In response to comments made at the plan commission meeting on August 8, 2016, we have made some improvements to the floor plan and site plan for the 418 Division Street project. Attached are 17 copies of those plans for staff review and distribution to the plan commission.

PROJECT TITLE  
**418 Division St.**

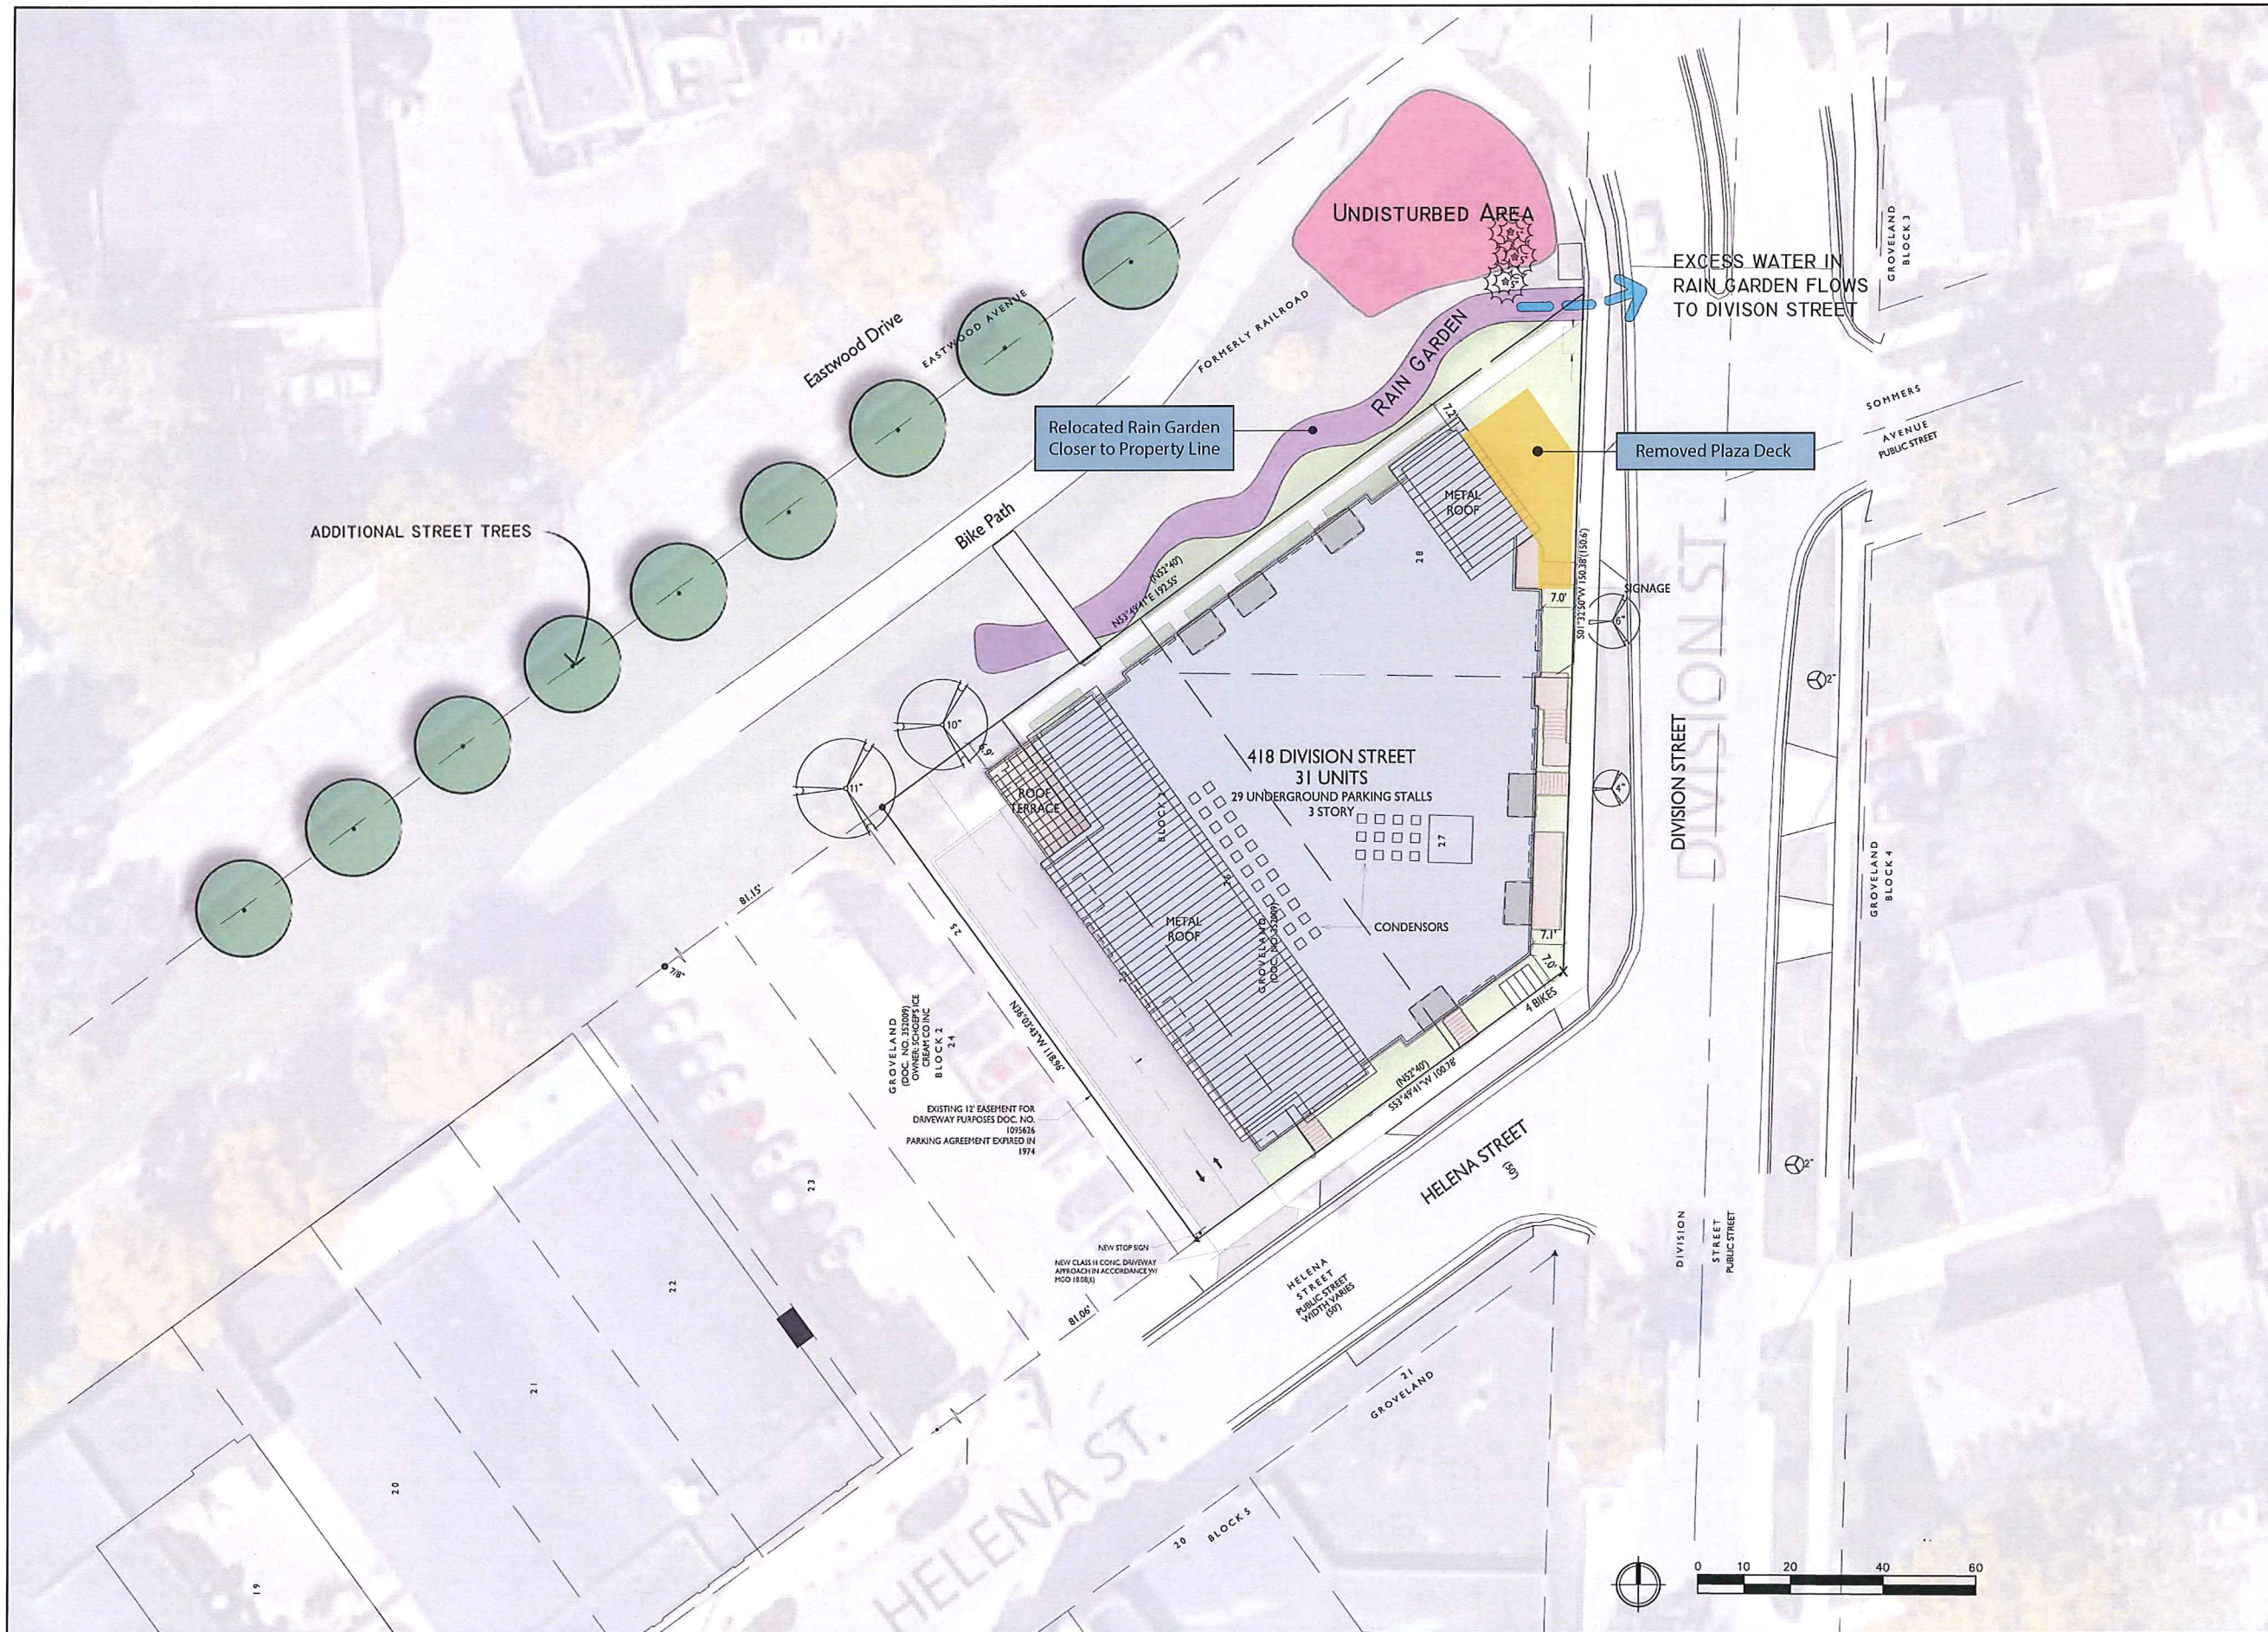
3. Improved the site plan. As a result of the redesign, the basement has become smaller and no longer extends outside the building footprint to the northeast. This results in the removal of the plaza deck at the northeast corner of the site and the ability to increase the landscaping at a key location on the site. Our intent is to work with the Marquette Neighborhood Association to design the landscaping in this area and along the rain garden so that it is complimentary to the existing MNA landscape feature on the bike path property.

4. Relocated the rain garden closer to the building. The rain garden has been shifted to minimize any "privatization" of the public bike path.
5. Increased the size of the porches and balconies. The porches and balconies at the first and second floor level were increased to 6'6" deep by 11' -14" in width. The third floor balconies were increased to 5'6" deep.

Madison, WI  
SHEET TITLE  
Basement Floor  
Plan

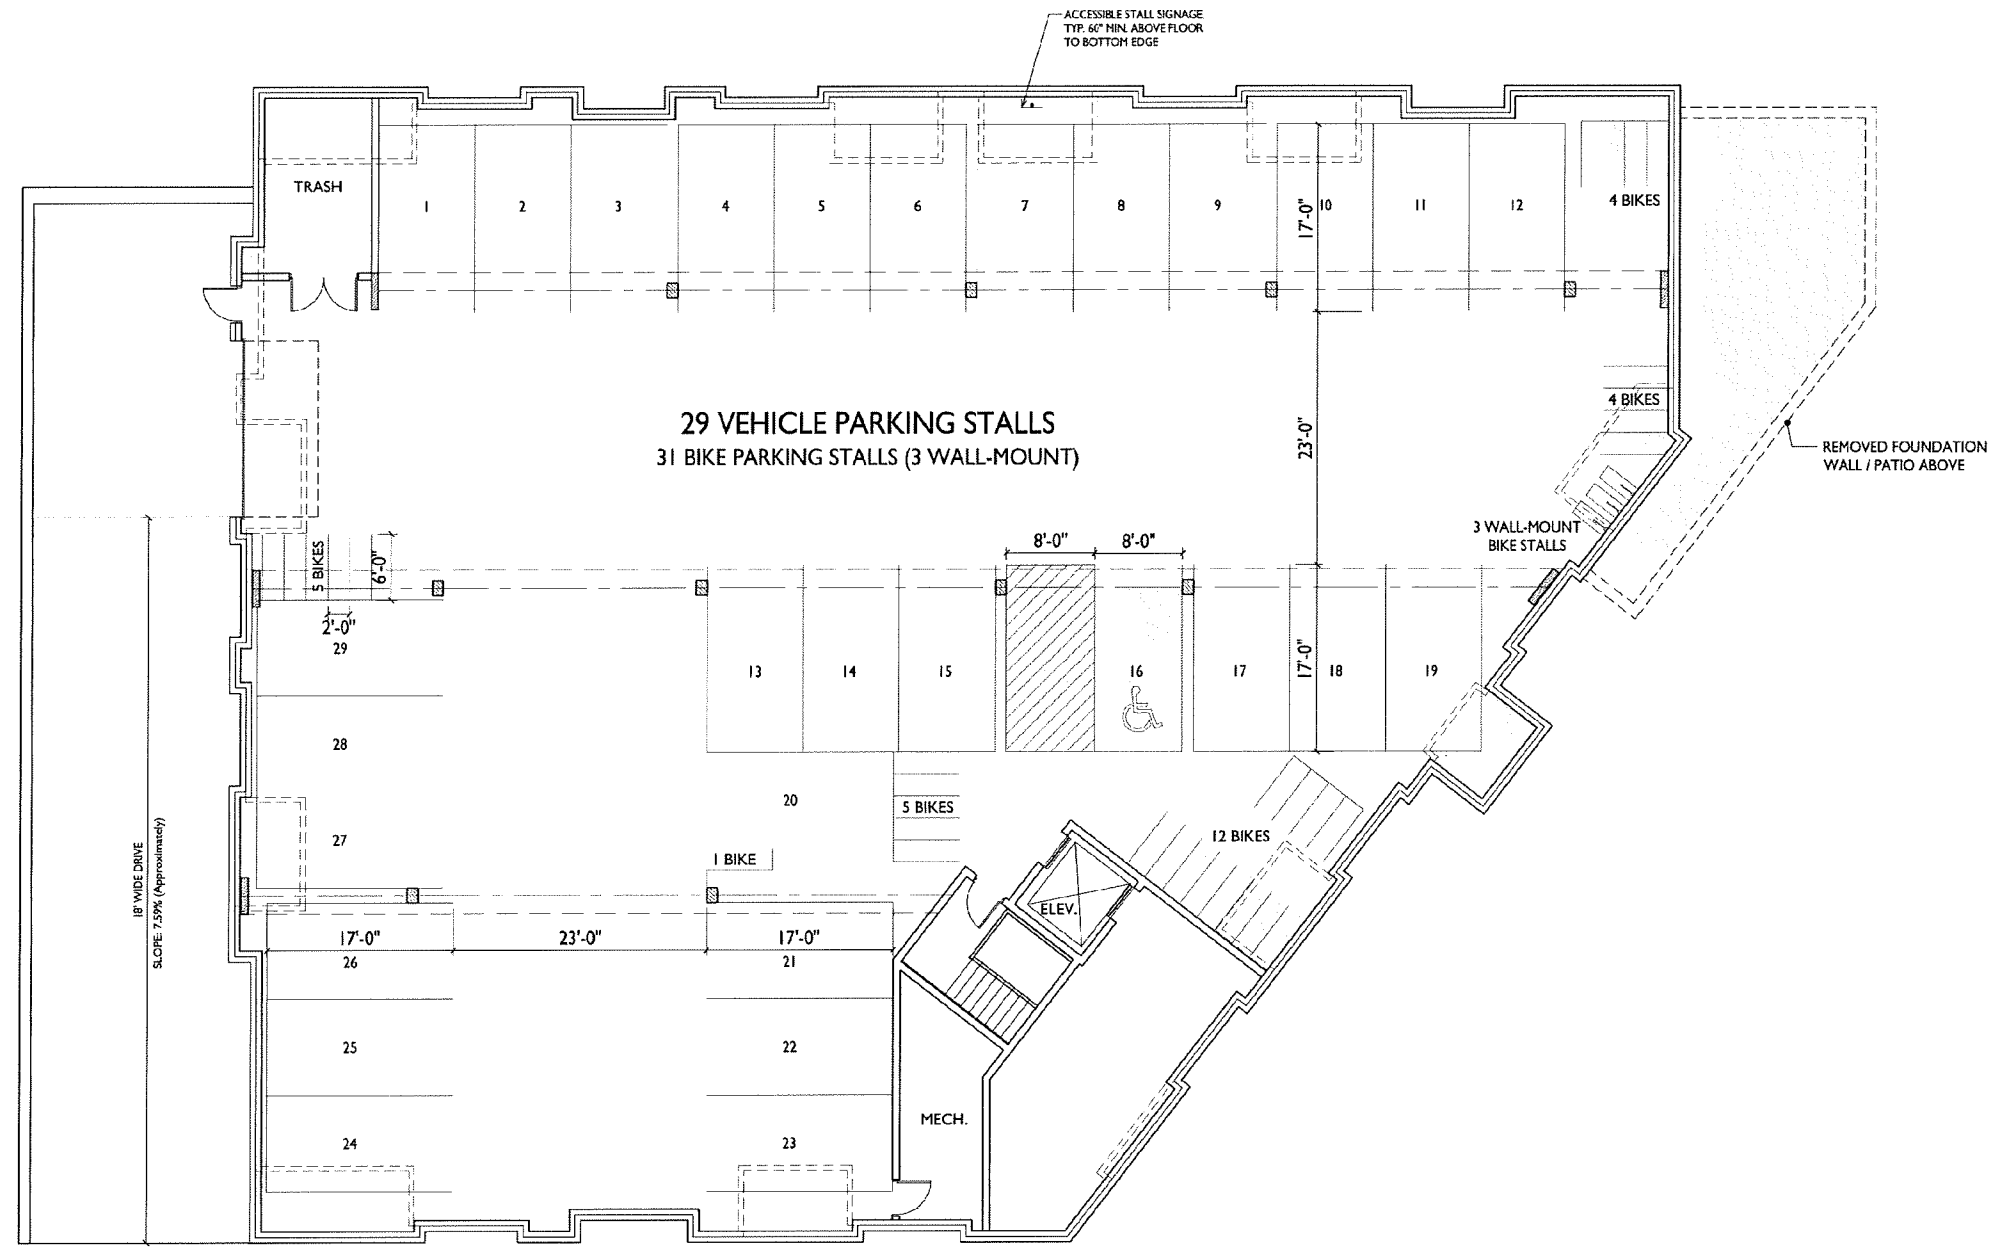
1. Improved bike parking in basement. The basement parking area was redesigned to relocate the 31 bike parking spaces as close to the elevator and the overhead door as possible. The number of car parking stalls remains at 29 stalls.

Madison, WI  
SHEET TITLE  
First Floor Plan

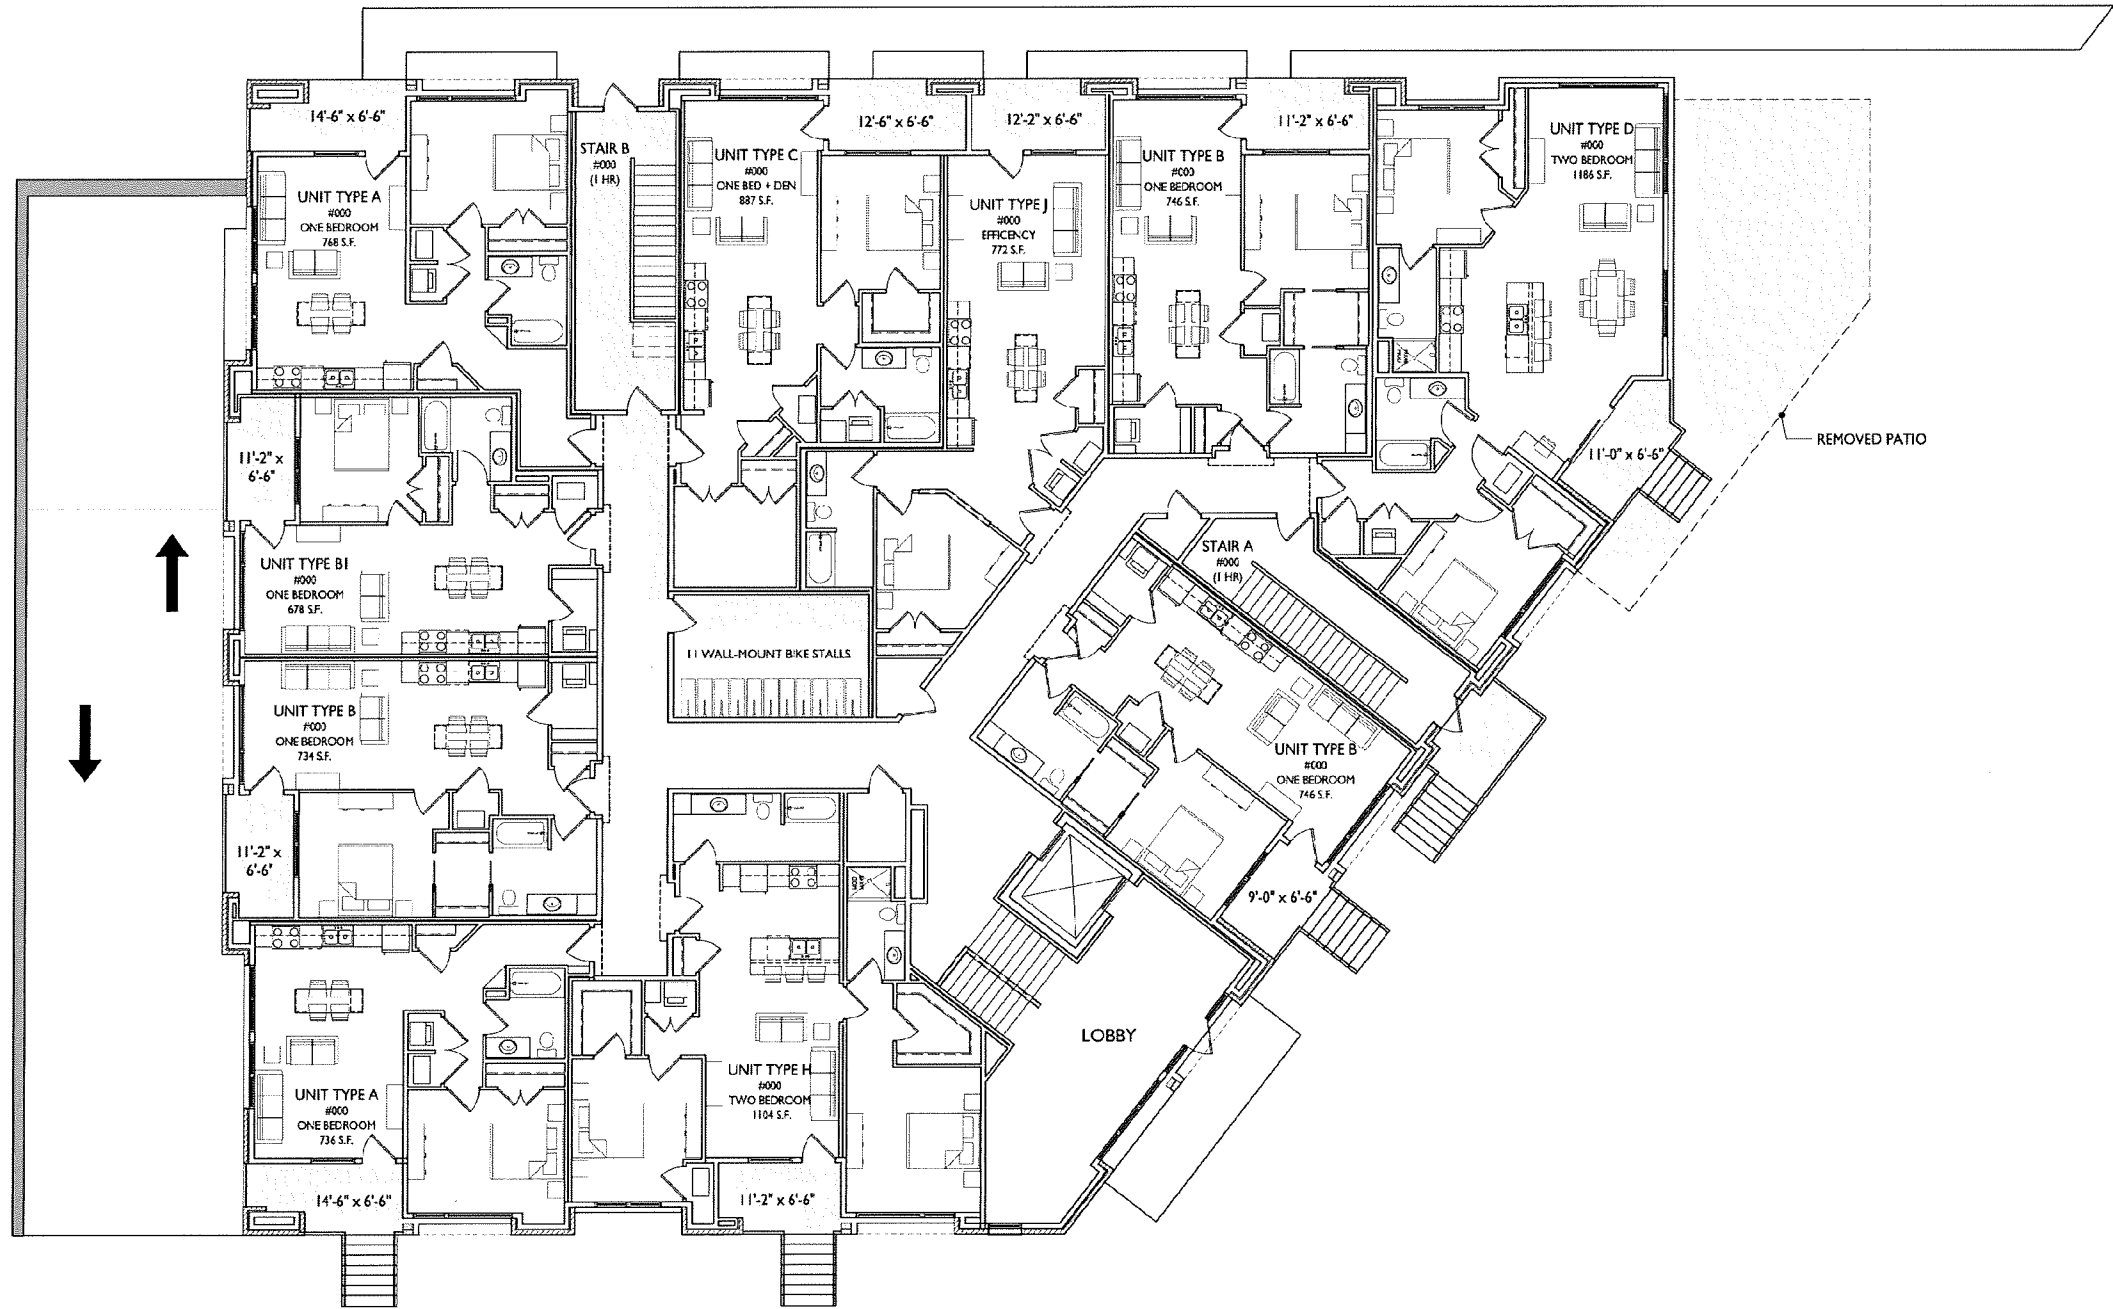
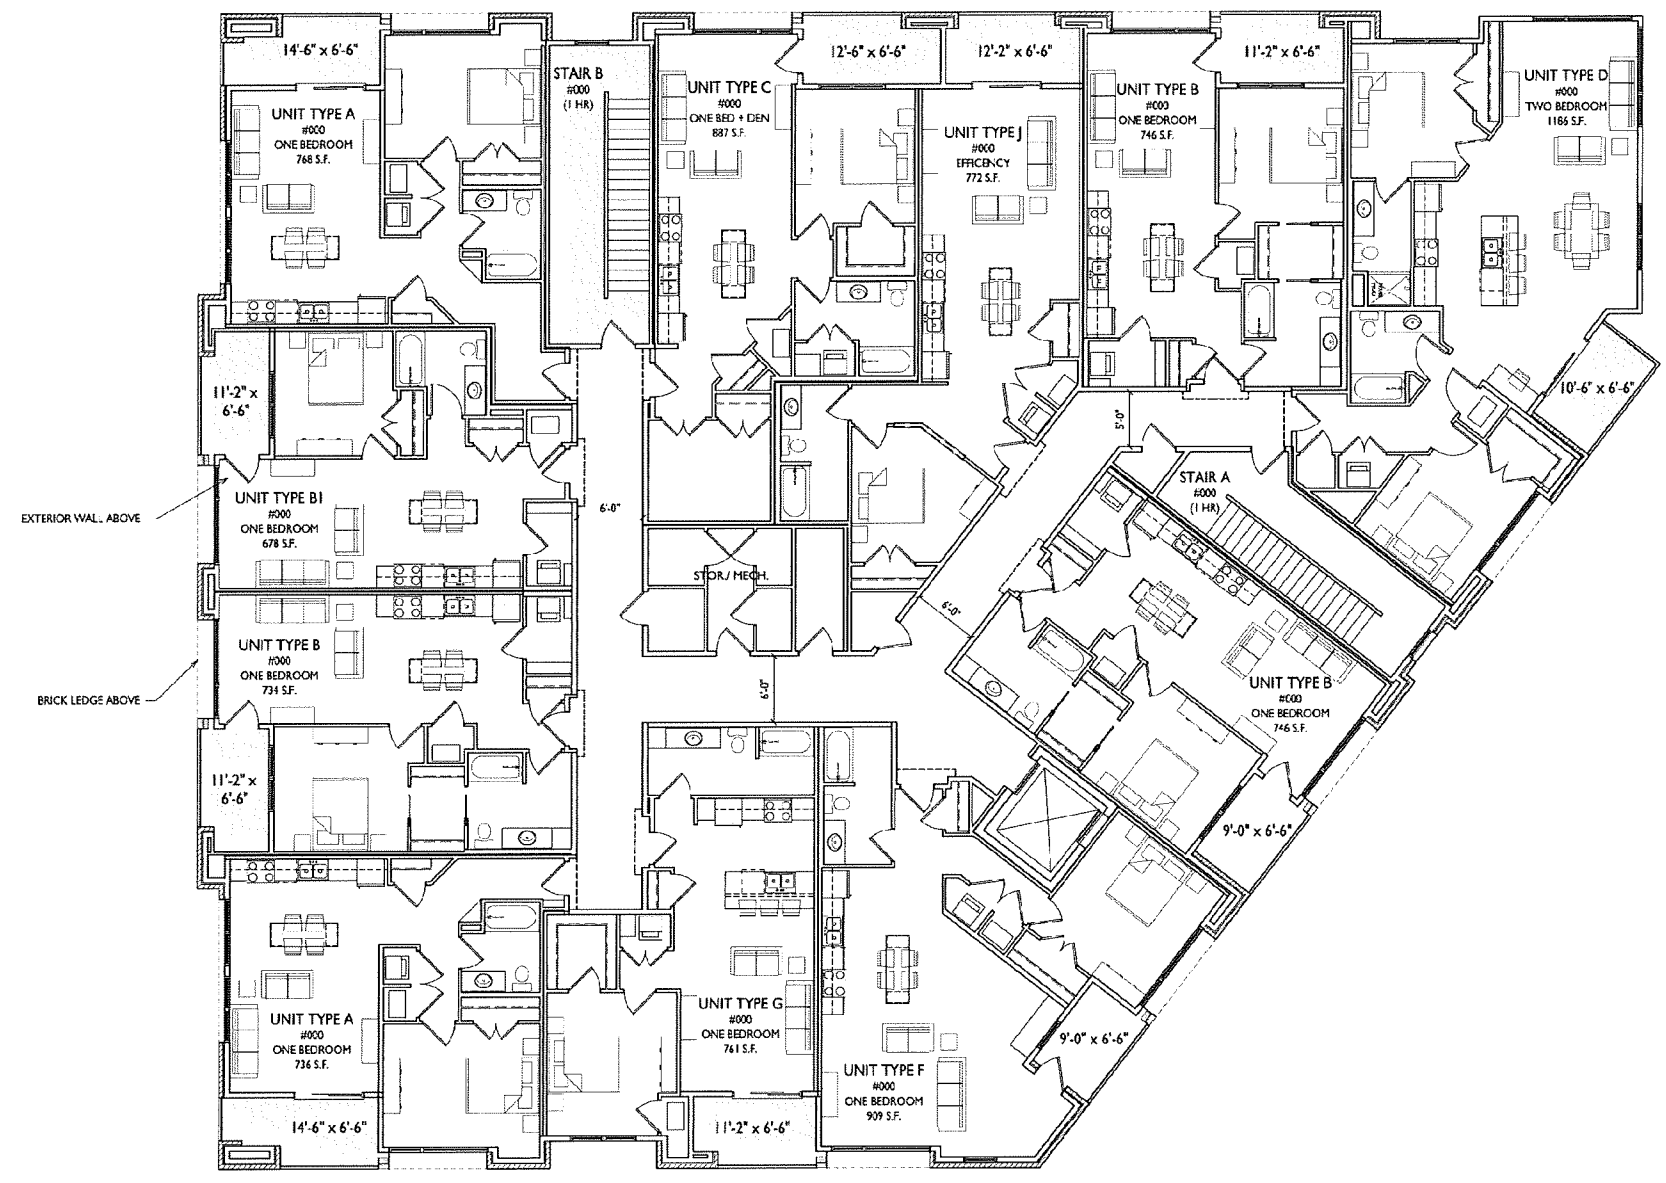
2. Added bike parking on the first floor. A bike storage room was added on the first floor near the rear entry door that leads directly to the bike path. Eleven wall mounted bike stalls are now conveniently accommodated at the main level.
